TAMPA BAY NITROGEN MANAGEMENT CONSORTIUM

2009 Reasonable Assurance Addendum: Allocation & Assessment Report

APPENDIX E: NMC Response to FDEP Comments on Final 2009 RA Addendum E1

Figure II-1: Time series of annual segment chlorophyll-*a* (µg/L).

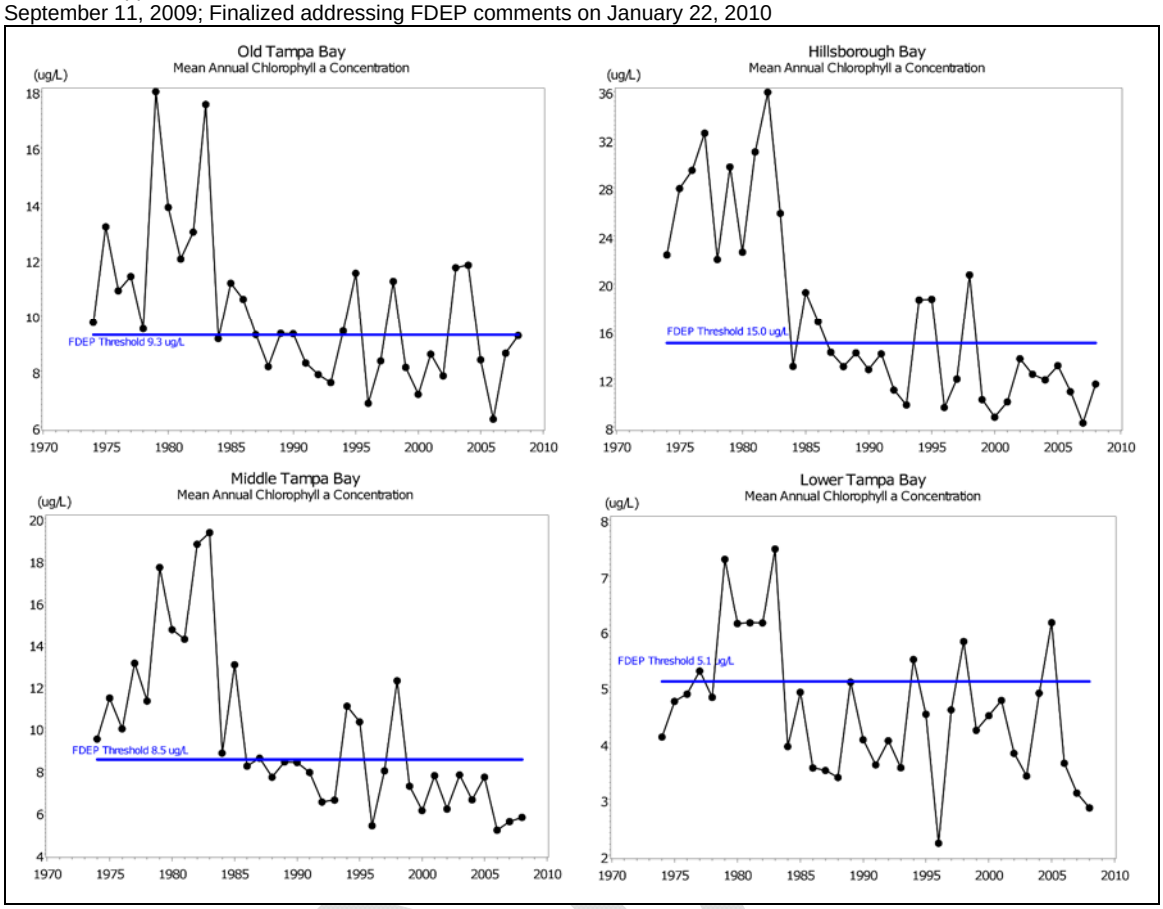
14. Page 8, Figure II-1. The chlorophyll-*a* water quality targets listed on page 10 would be a helpful reference if displayed on the maps.

Response: In an attempt to keep the graphics uncluttered, the thresholds have been listed in the text and with the compliance timeline shown in Figure II-5. However, they will be included on the map also.

Figure II-2: Time series of annual segment light attenuation (m^{-1}).

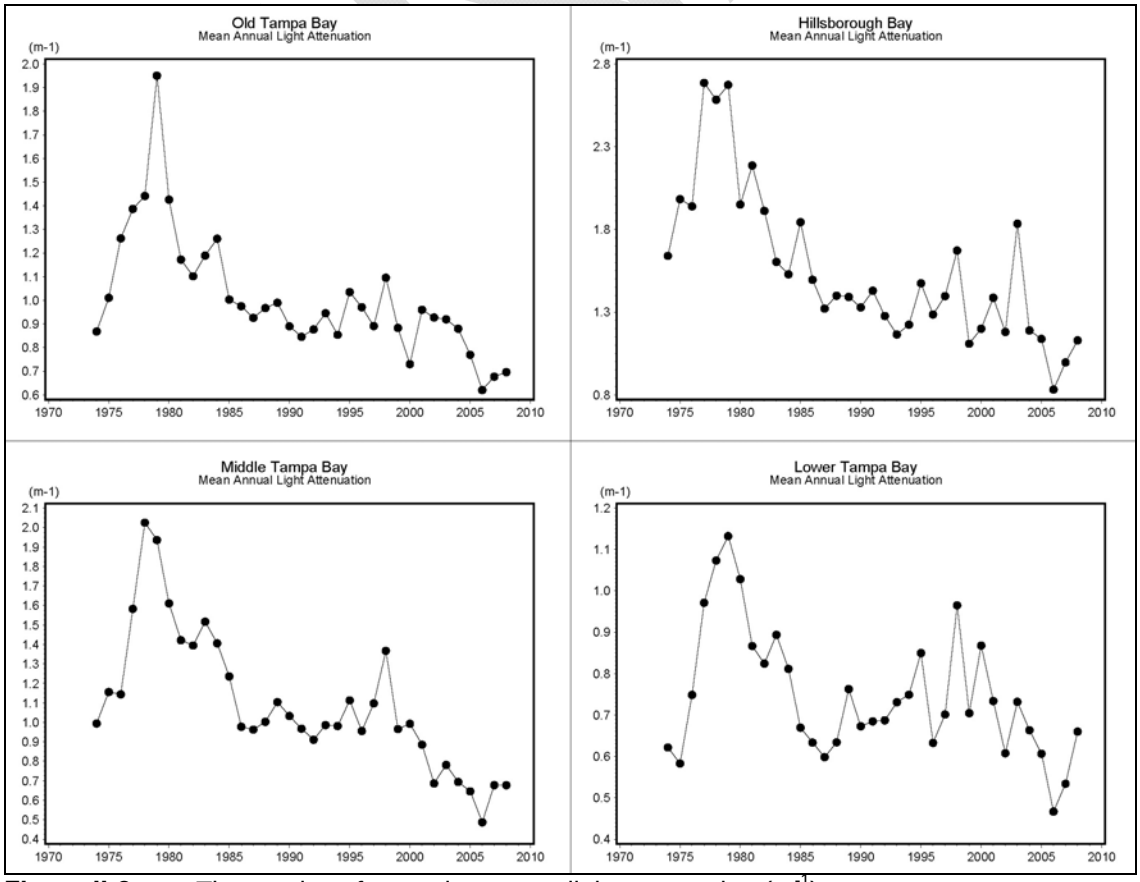
13. Page 8, Figure II-2. Are there light attenuation benchmarks?

Figure IV-8. Time series of annual Nitrogen Delivery Ratio (tons TN/million m^3) to Hillsborough Bay, 1985-2007. The blue horizontal line equals 1.62.

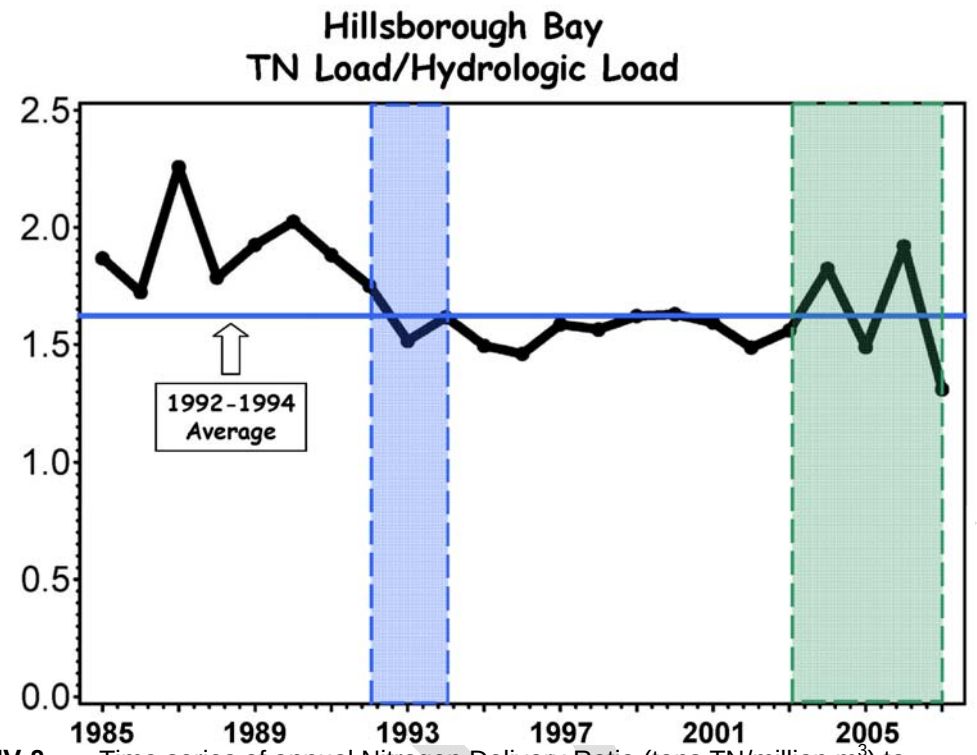
26. Page 32, first paragraph. Include a sentence noting that the Hillsborough Bay Nitrogen Delivery Ratio was exceeded in two year between 2003-2007 (as shown on Figure IV-8), but that chlorophyll-*a* thresholds were not exceeded.
